ADVANCED NUCLEAR FUELS CORPORATION
METHODOLOGY FOR BOILING WATER REACTORS
EXEM BWR EVALUATION MODEL

November 18, 1992

SUBJECT: ACCEPTANCE FOR REFERENCING OF TOPICAL REPORT ANF 91-048(P),
"ADVANCED NUCLEAR FUELS METHODOLOGY FOR BOILING WATER REACTORS EXEM
BWR ECCS EVALUATION MODEL"

FIGURE 5.2

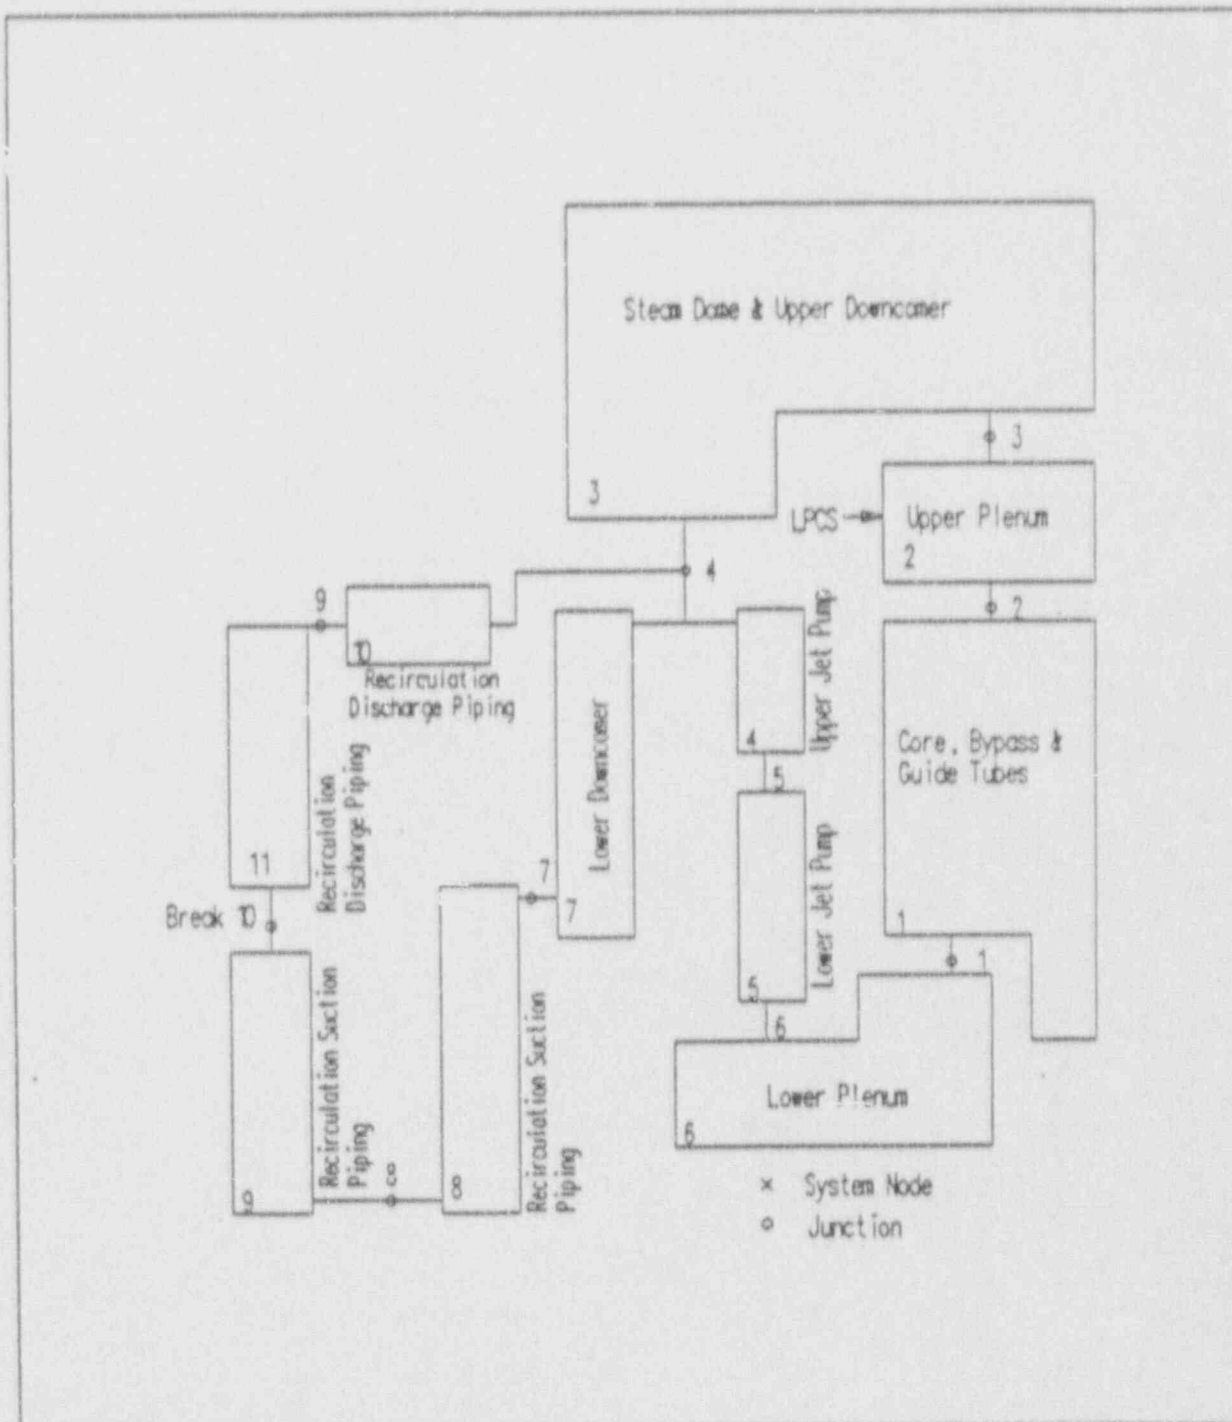
The standard application of the phase separation model to the system nodes (see Figure 5.2) using the currently approved evaluation model is as follows:

In order to be consistent with plant EM analyses, the FLEX calculation was initialized using the conditions calculated by RELAX at the end of the blowdown period (LPCS at rated spray). Since the ECCS spray never reached a steady rated spray condition, the refili/reflood period was initiated when the LPCS reached a near asymptotic value (80% at 136 seconds). This time was characterized by a significant change in the slope of the LPCS delivery curve. The submittal for the currently approved ECCS EM began the FLEX calculation when only the HPCS reached a near asymptotic value (95% with LPCS at 65%). Nodal masses, pressures, passive heat conductor temperatures and heater rod temperatures were initialized by automatic data transfer from the RELAX results. The data transfer process employed the same methodology used in actual licensing analysis. The FLEX system nodalization used in the simulation of Test 6406 is shown schematically in Figure 5.2. This is the standard FLEX nodalization used in ANF EM analyses.
